WILLIAMSON COUNTY, TEXAS

CHANGE ORDER NUMBER: 3

Project:	<u>1603-062</u>
Roadway:	<u>CR 258</u>
CSJ Number:

Change Order No. 3

OWNER: WILLIAMSON COUNTY, TEXAS
 RECONSTRUCTION OF COUNTY ROAD 258
 CR 258
 PLAN AND PROFILE
 STA. 73+00 TO STA. 77+00
 SHEET 2 OF 24

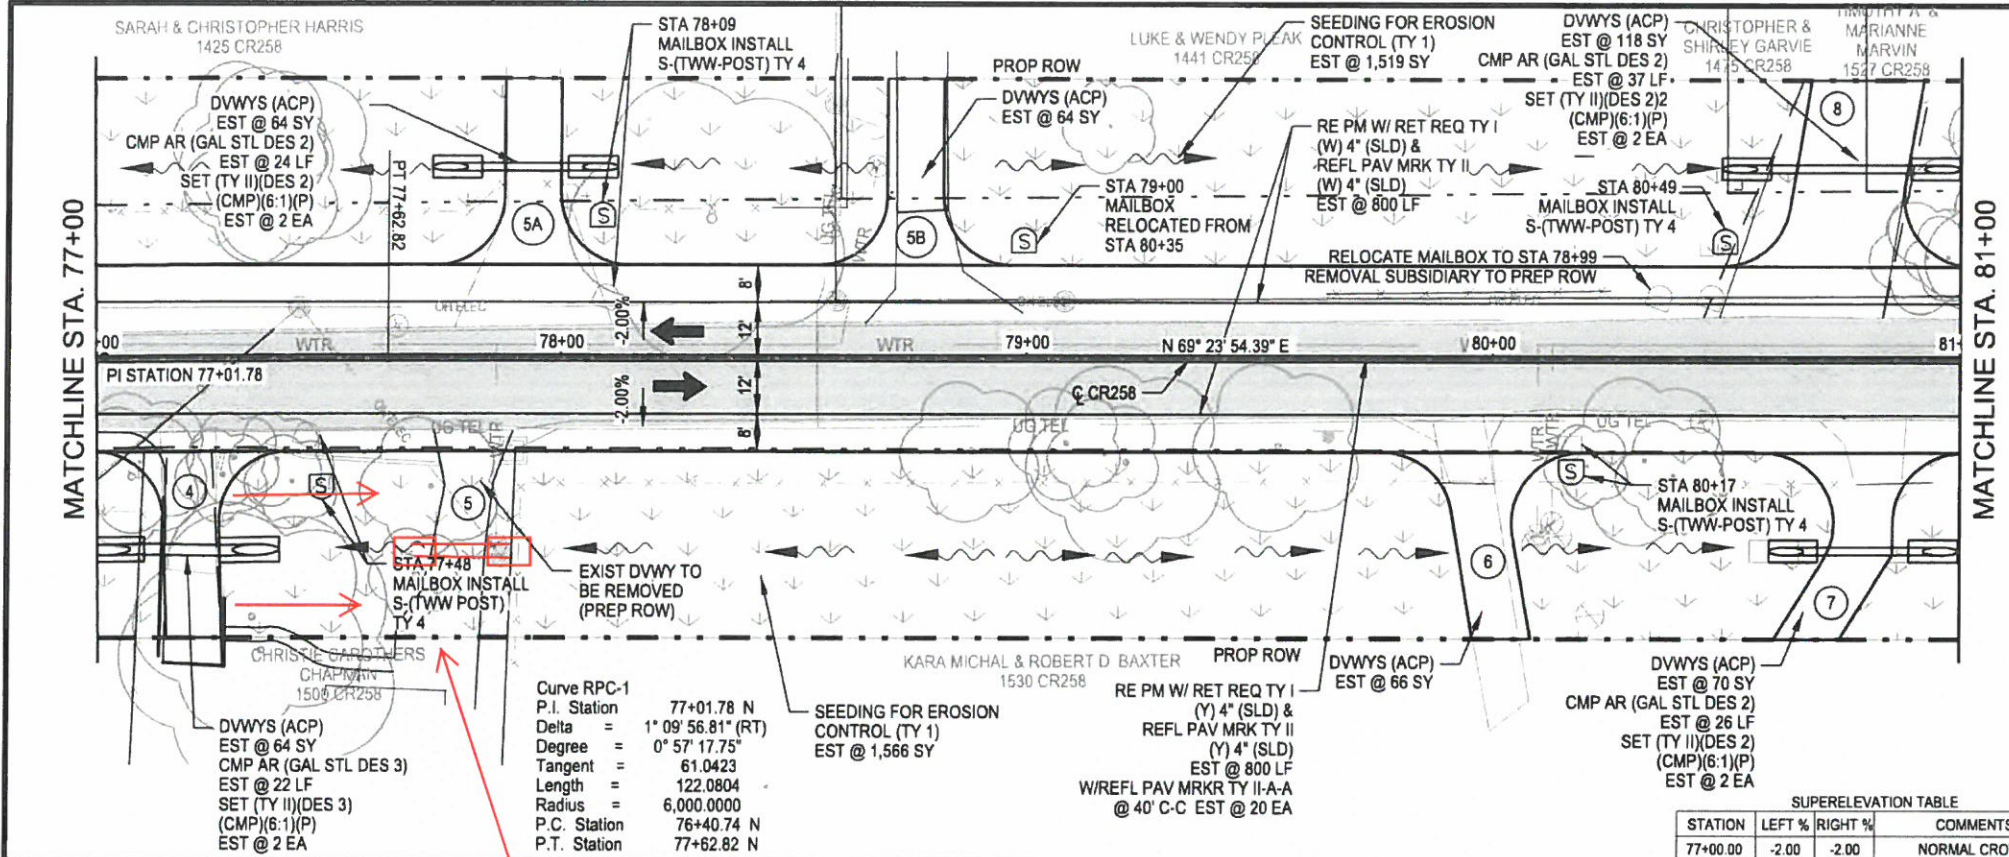
Driveway 1A, at approximate Station 73+00, was relocated to Station 75+14 at the request of the property owner. The driveway culvert pipe was extended to the west approximately 51 feet from Driveway 2, to accommodate the new location for Driveway 1A.

RECONSTRUCTION OF COUNTY ROAD 258
CR 258
PLAN AND PROFILE
STA. 77+00 TO STA. 81+00
SHEET 3 OF 24

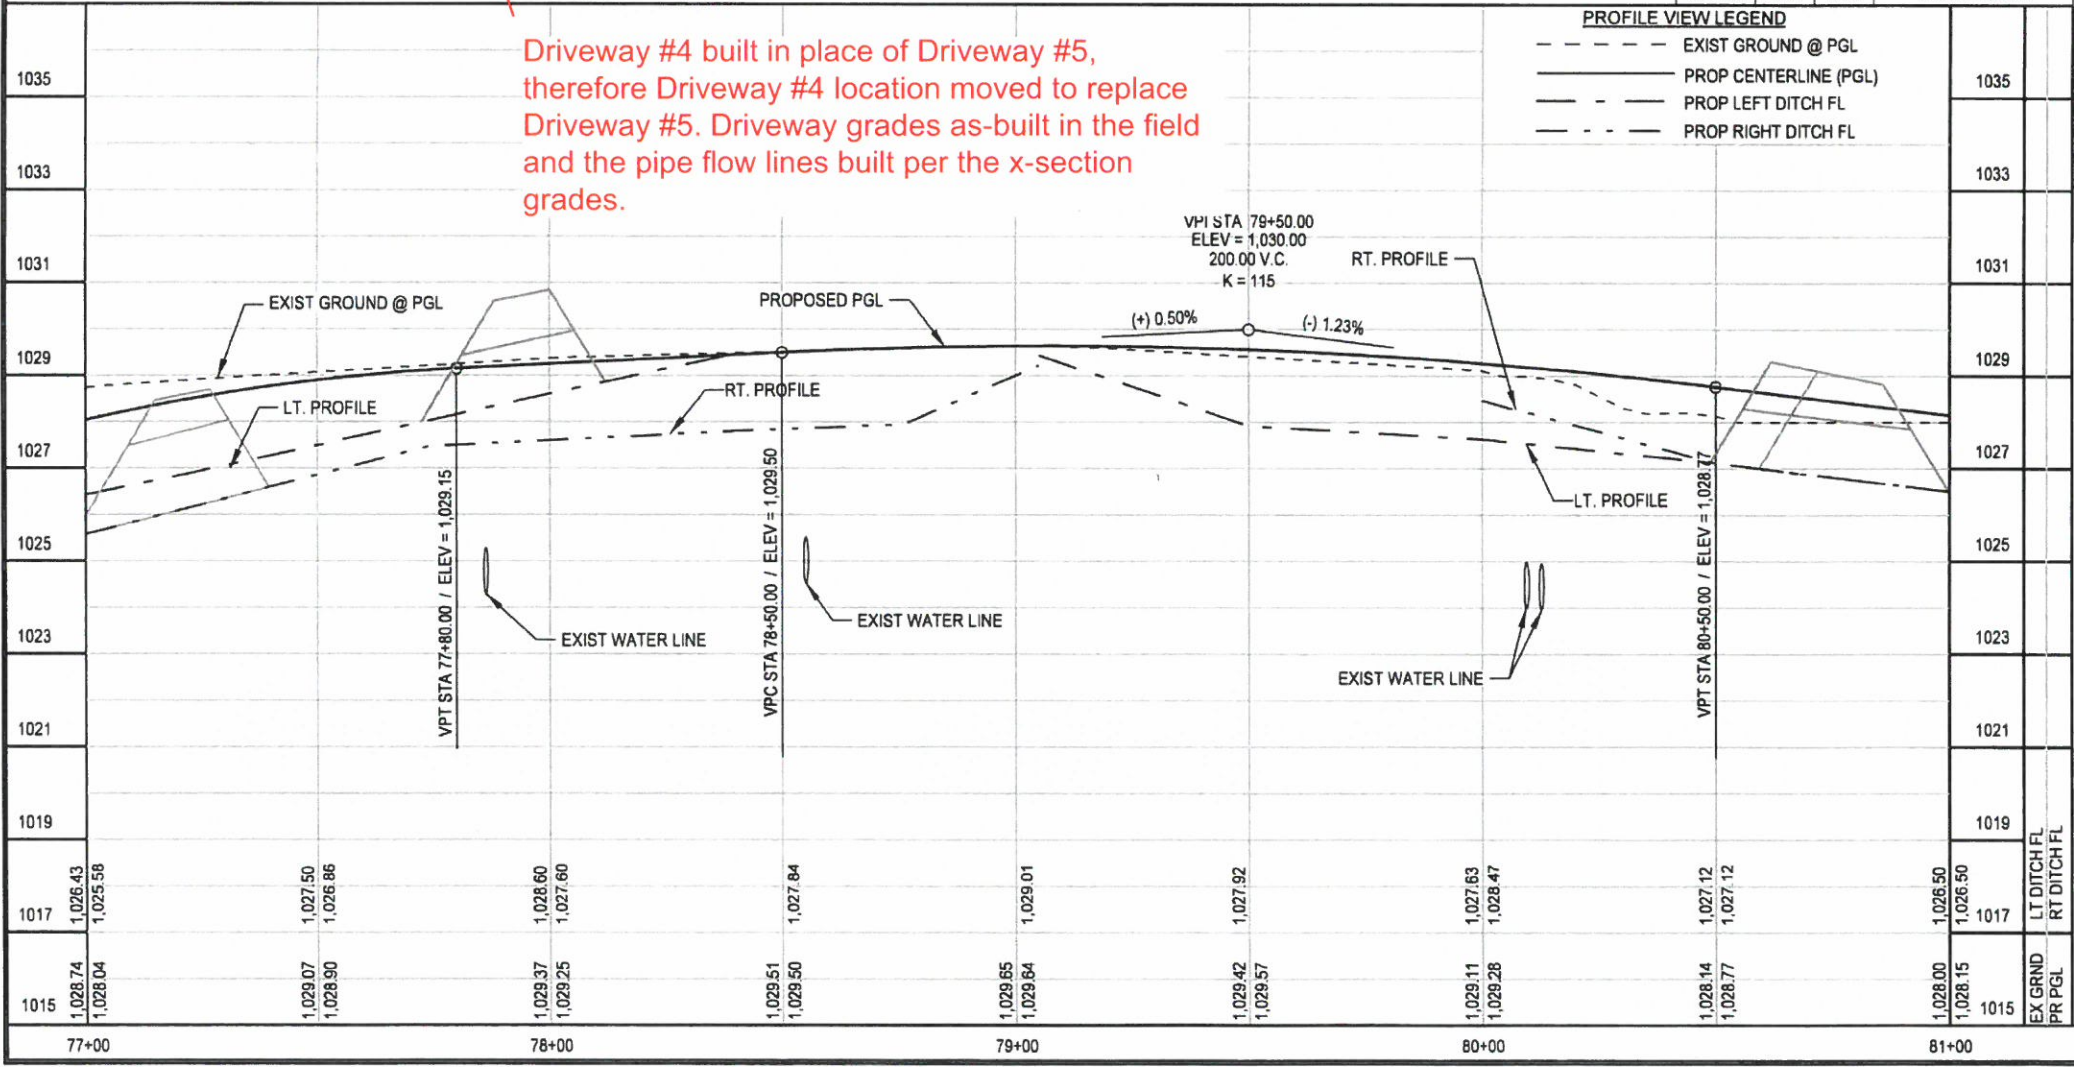
Per the plans, proposed Driveway 4 (Sta. 77+25) is a new asphalt driveway and Driveway 5 (Sta. 77+75) is an existing concrete driveway to be removed. Due to existing conditions and landowner access needs, Driveway 5 was removed and Driveway 4 was moved to the same station and built as concrete.

Driveway #4 built in place of Driveway #5, therefore Driveway #4 location moved to replace Driveway #5. Driveway grades as-built in the field and the pipe flow lines built per the x-section grades.

ADDITION OF DRIVEWAY 25A, PIPE CULVERTS AND RAILING.

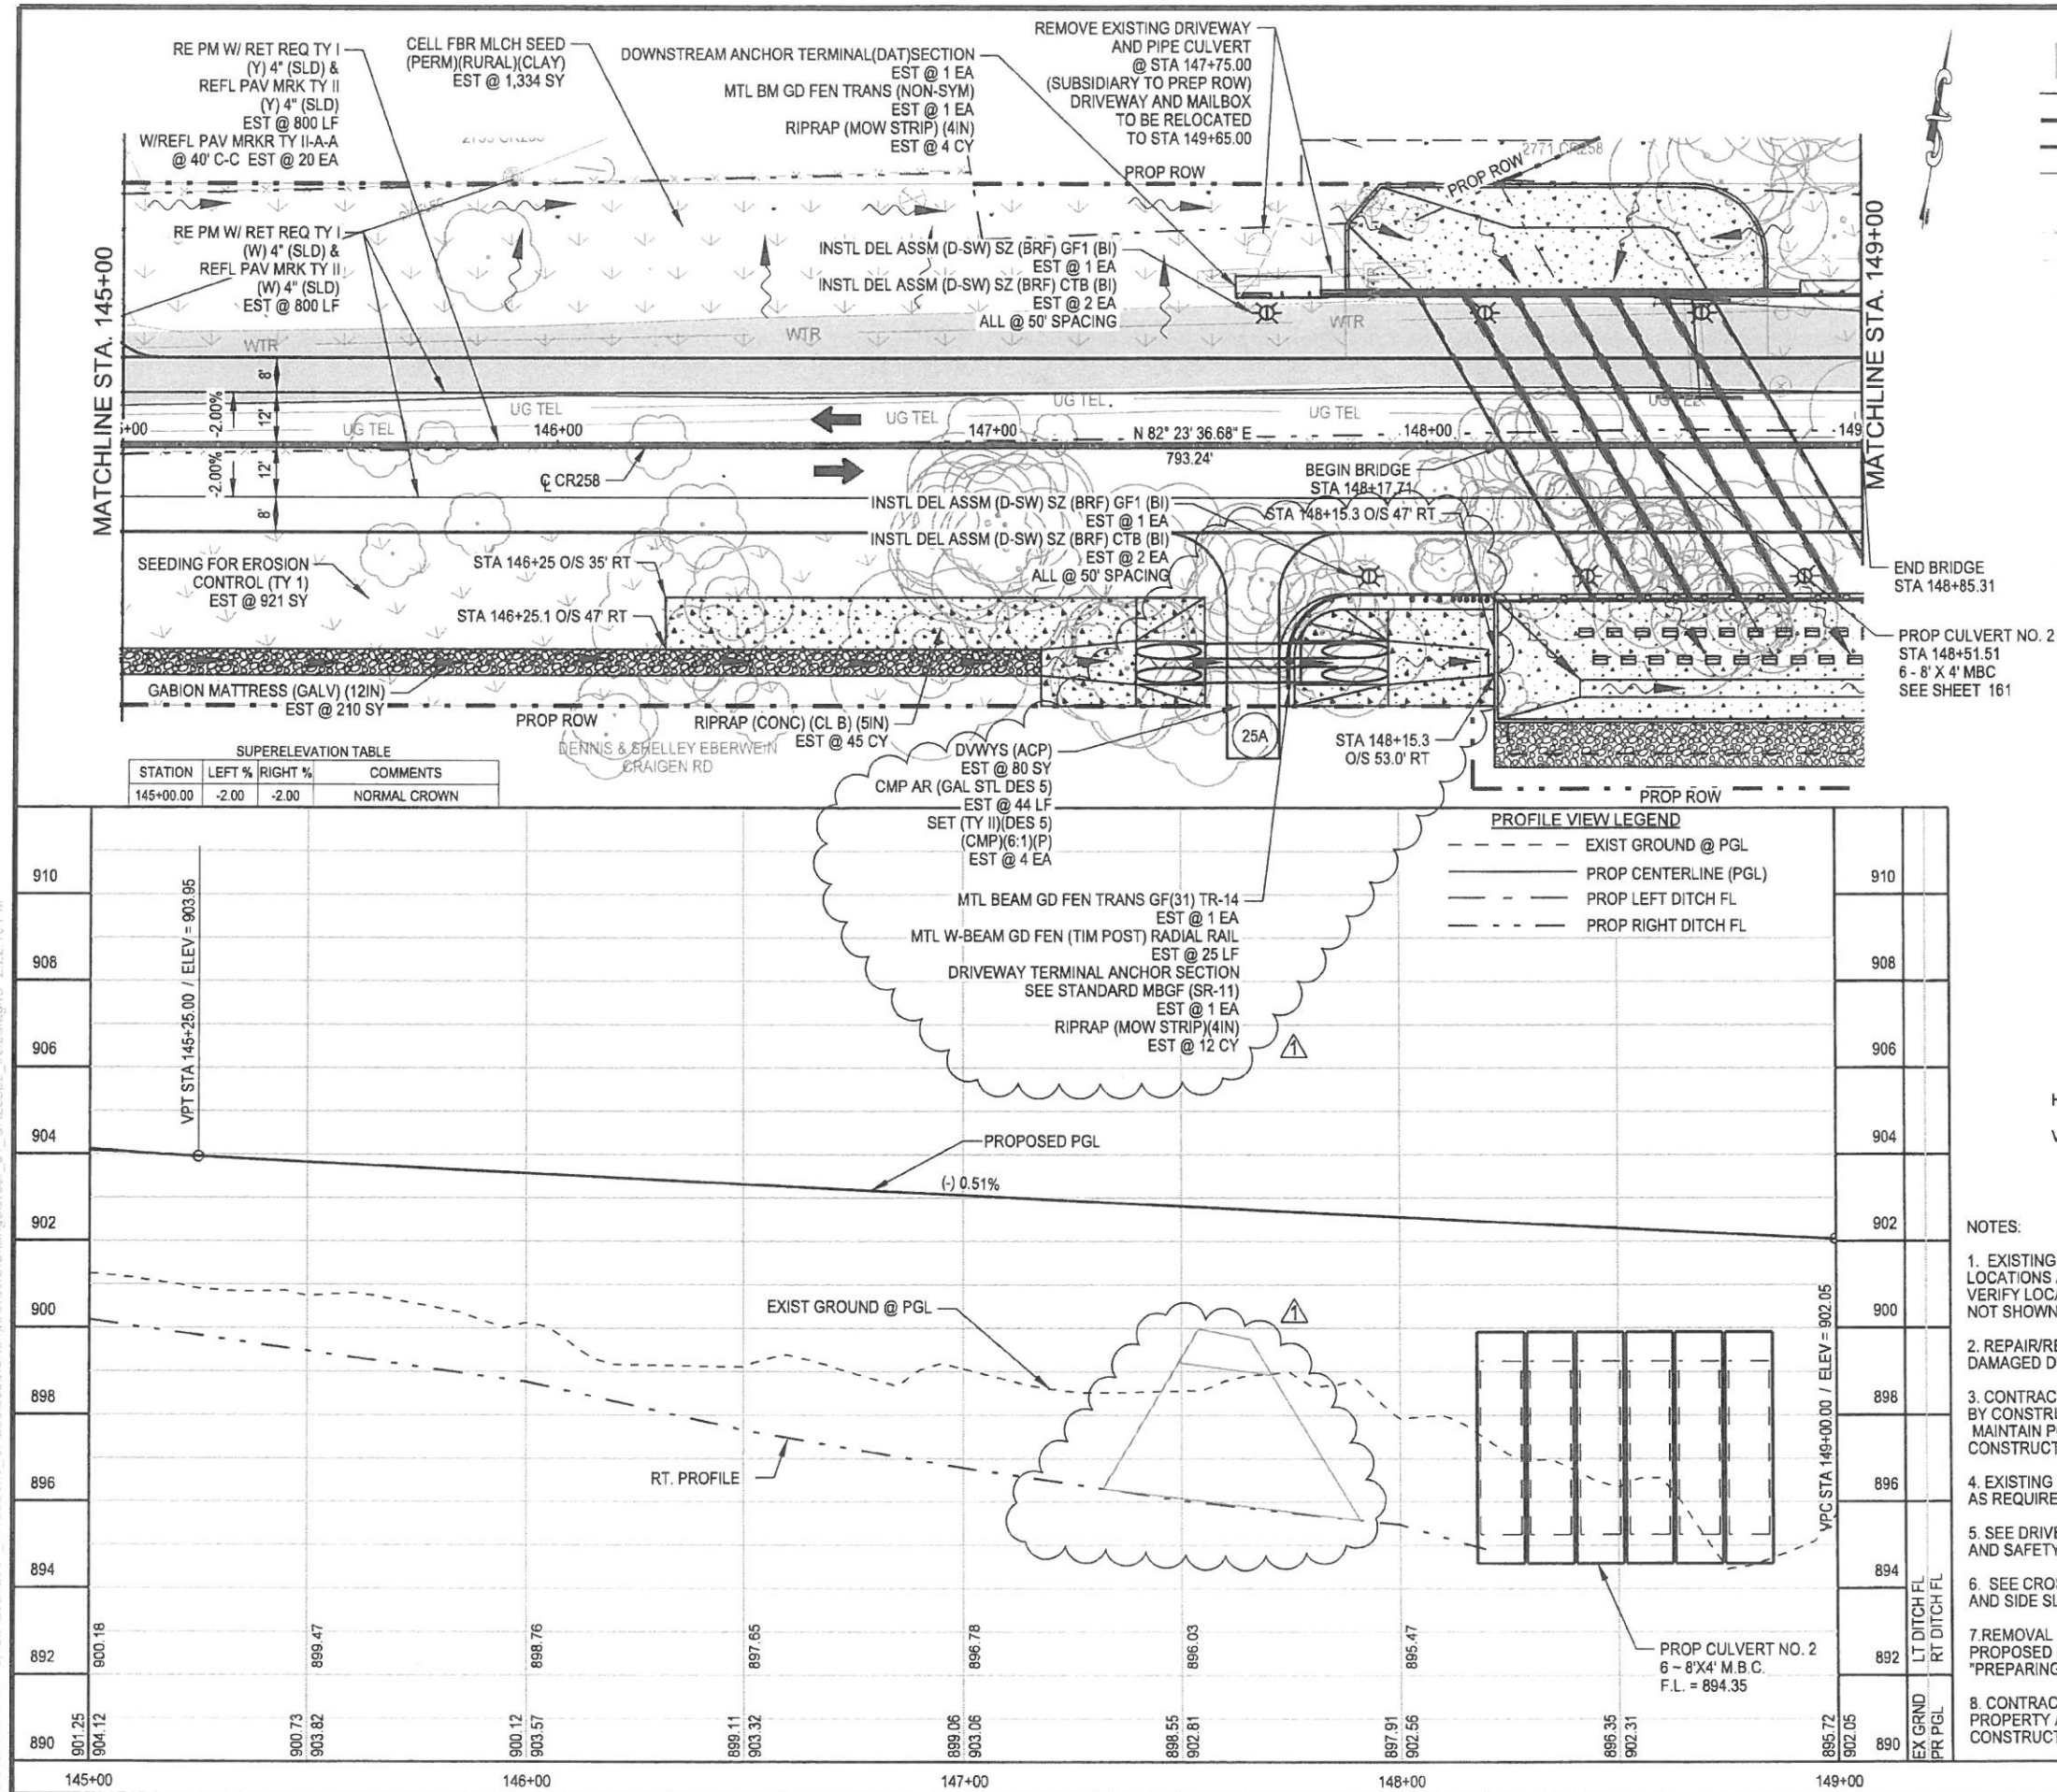
An adjacent property owner (Mr. Mosner) requested construction of a new driveway to his property that was not shown in the bid plans. The landowner received a permit from the County, just prior to the beginning of construction, approving Driveway 25A located at Station 147+60. The construction of the driveway includes, culvert pipes, safety end treatments and metal beam guard rail along the driveway radii. This is the property owner's only access to his property.
